**Section 16 Planning Application for Proposed Temporary Open Storage of Modular Integrated Construction Components and Construction Materials with Ancillary Workshops, Office, Staff Car Park and Machinery for a Period of 3 Years at Lot Nos. 1555 S.A (Part), 1555 S.B RP (Part), 1557 RP (Part), 1558 (Part) and 1559 (Part) in D.D. 107, Sha Po, Kam Tin, Yuen Long, New Territories (Planning Application No. A/YL-KTN/981)**

We refer to the latest comments from Lands Department, Drainage Services Department and Environmental Protection Department and would like to enclose herewith our Responses-to-Comments Table to address the abovementioned departmental comments for their consideration.

Section 16 Planning Application for Proposed Temporary Open Storage of Modular Integrated Construction Components and Construction Materials with Ancillary Facilities for a Period of 3 Years at Lots 1555 S.A (Part), 1555 S.B RP (Part), 1557 RP (Part), 1558 (Part) and 1559 (Part) in D.D. 107, Cheung Chun San Tsuen, Kam Tin, Yuen Long, New Territories

### **Drainage Proposal**

Figure 3-2 Indicative Proposed Drainage Diversion Layout

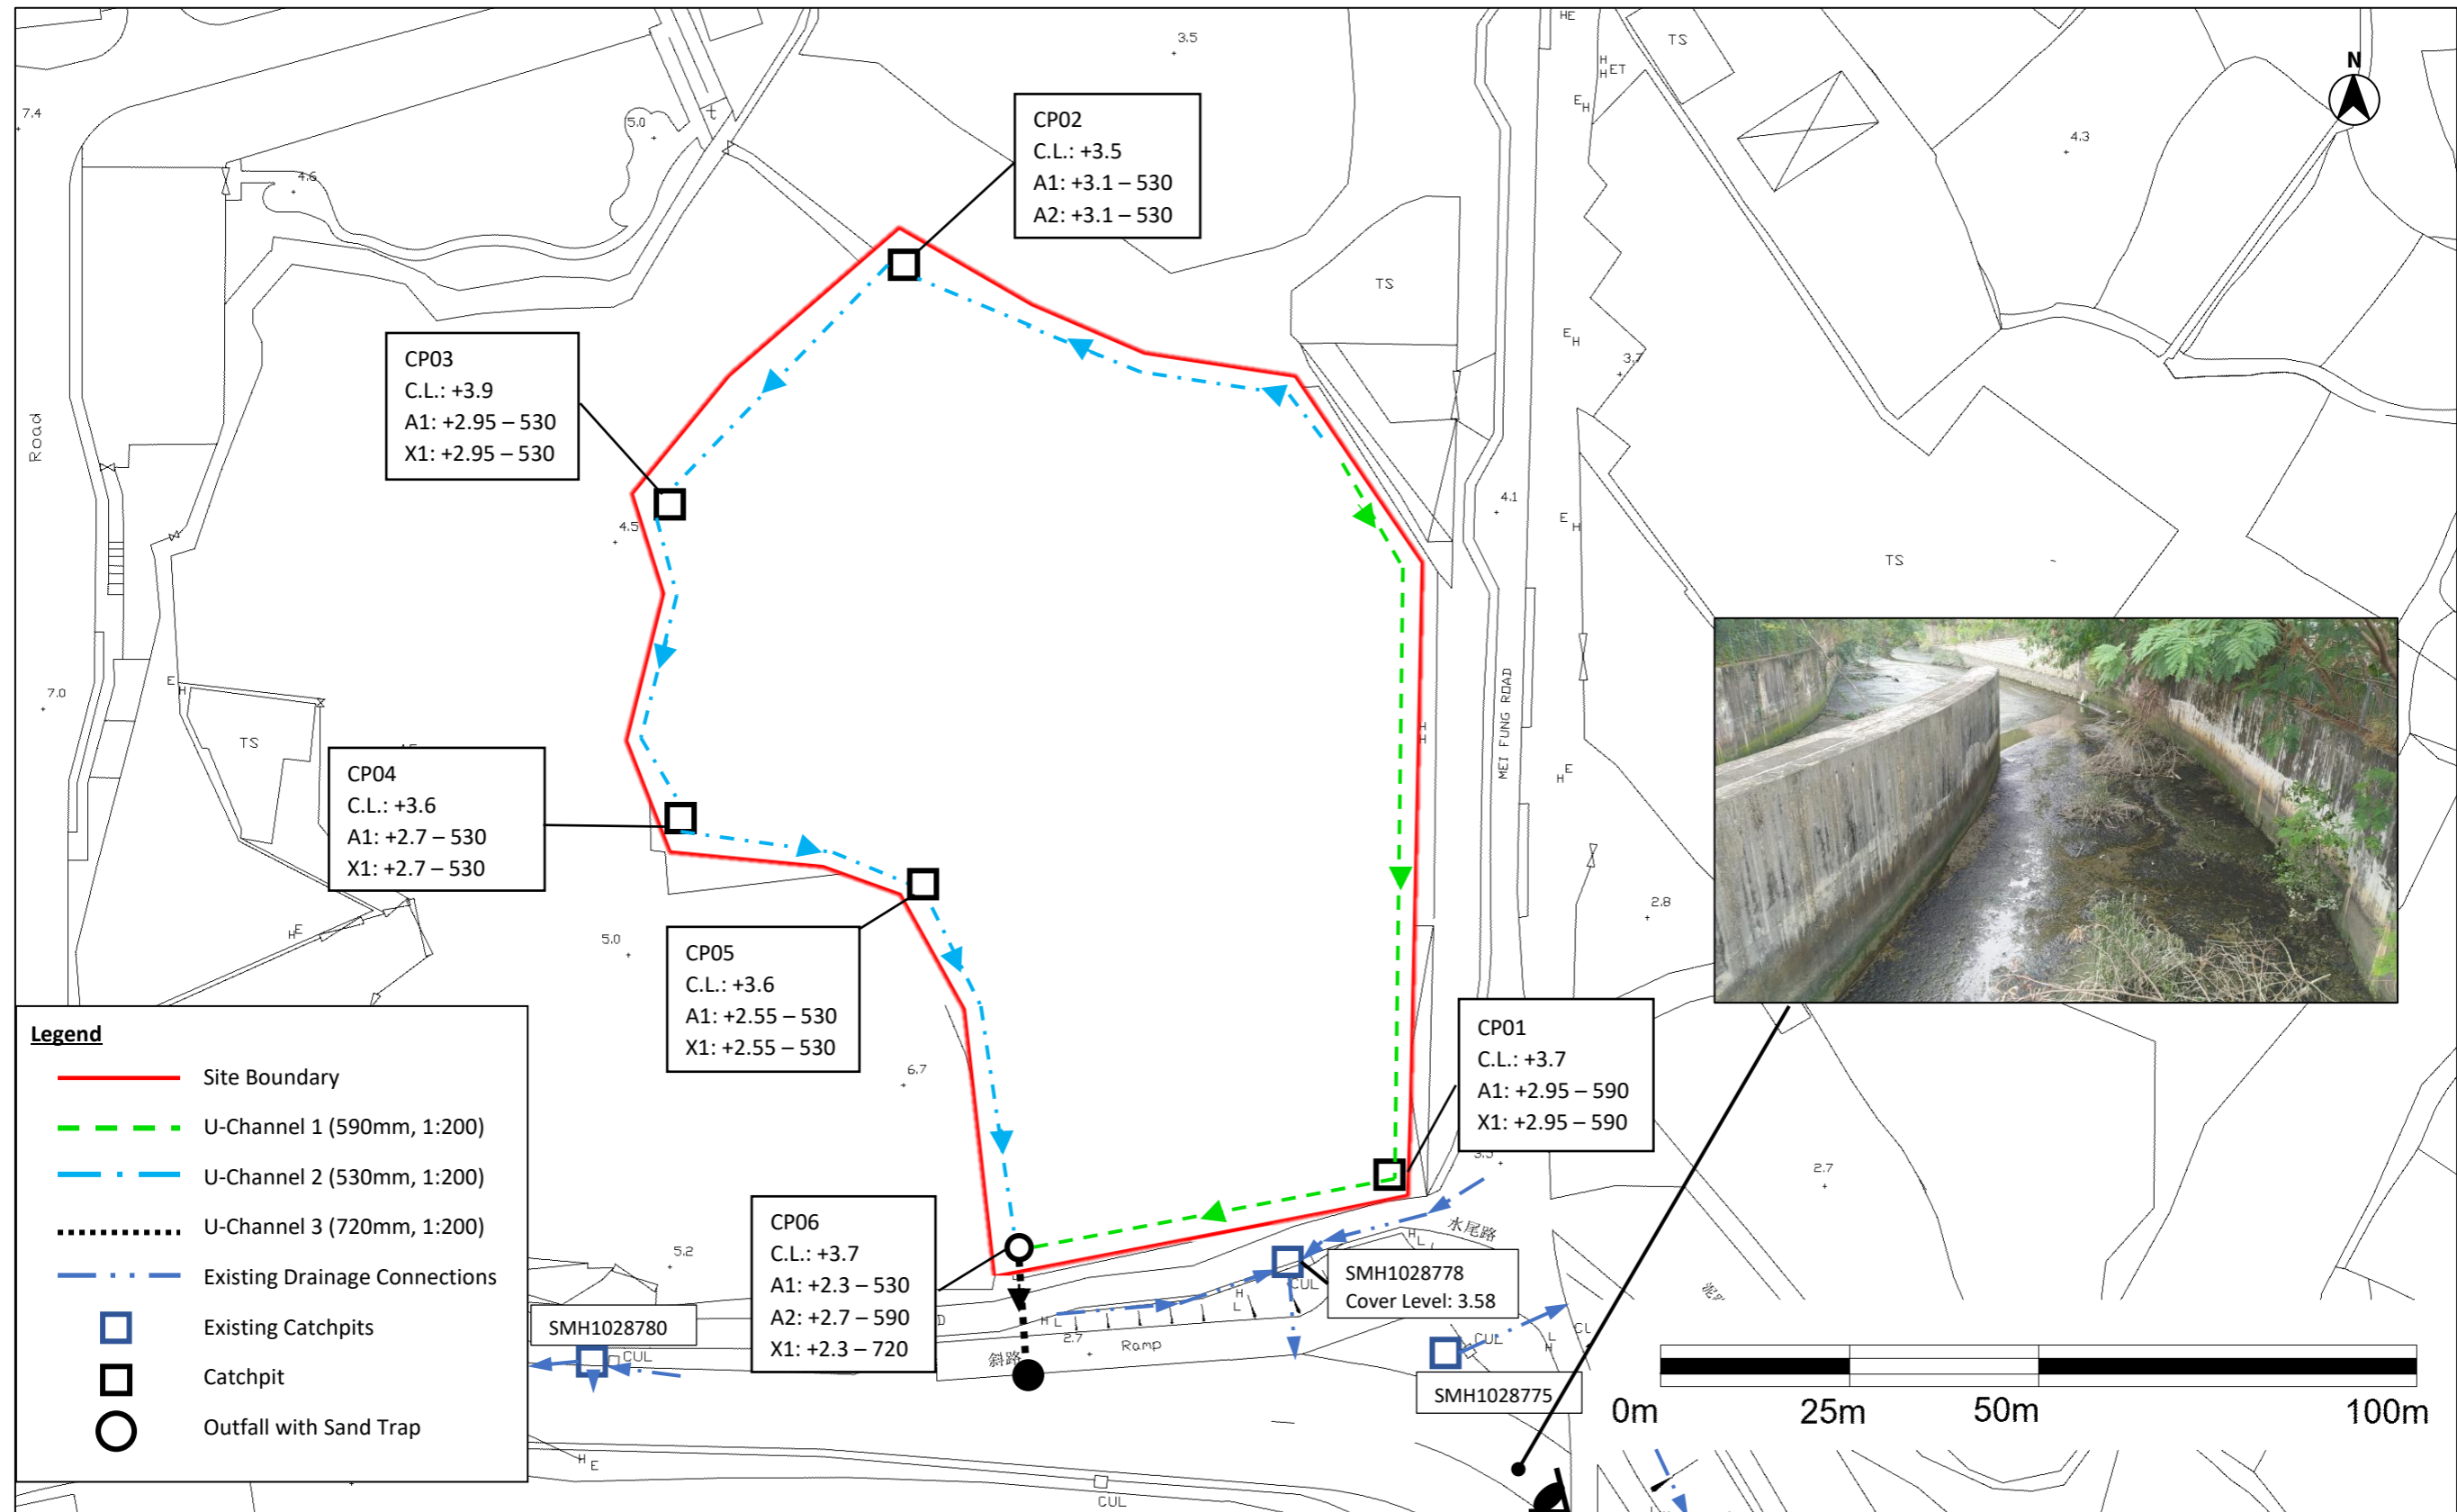
Department	Date	Comments	Responses to Departmental Comments
Drainage Services Department (DSD)	20.02.2024	<p>(i) Para. 3.4.1: Please revise the para. That the purpose of drainage proposal is to identify and provide detailed drainage design to justify the feasibility of the implementation of drainage facilities. As such, detailed invert levels and relevant drainage scheme should be provided for comment in this stage.</p> <p>(ii) Please advise if any site formation/ land filling works to be carried out under this application. Please note that the overland flow from the adjacent lands should not be affected.</p> <p>(iii) Figure 3-1: There are two catchment B in the figure, please revise.</p> <p>(iv) Please indicate the existing public drainage facilities in the vicinity on figure 3-2 for reference.</p> <p>(v) Please explain why the final discharge outlet point not to connect the existing catchpit no. SCH1028778 such that construction of outlet pipe length can be reduced. However, in such case, checking/ upgrading on the discharge condition of outlet pipe DN600 of this catchpit is needed.</p> <p>(vi) The cover and invert levels of the proposed u-channels and catchpits should be shown on the drainage plan.</p>	<p>(i) Noted and revised.</p> <p>(ii) As mentioned in para. 2.1.2 of the Planning Statement, the Site is a gentle flat land. With careful design of site formation and landscape works, no significant cutting/filling works will be required. This is also in line with Item (e)(ii) Part 6 Type(s) of Application Form No. S16-III which no filling of land and excavation of land will be carried out.</p> <p>(iii) Typo and corrected.</p> <p>(iv) Noted and amended, please refer to the revised Figure 3-2 for details.</p> <p>(v) The final discharge outlet point is not connected to the existing catchpit no. SCH1028778 because the capacity of the existing pipe no. SWD1065697 may not be enough. Instead, it is recommended to divert the runoff to a new drain indicated to be U-Channel 3 as shown in Figure 3-2.</p> <p>(vi) Noted, Figure 3-2 has been amended to include invert and cover levels of proposed u-channels and catchpits.</p>
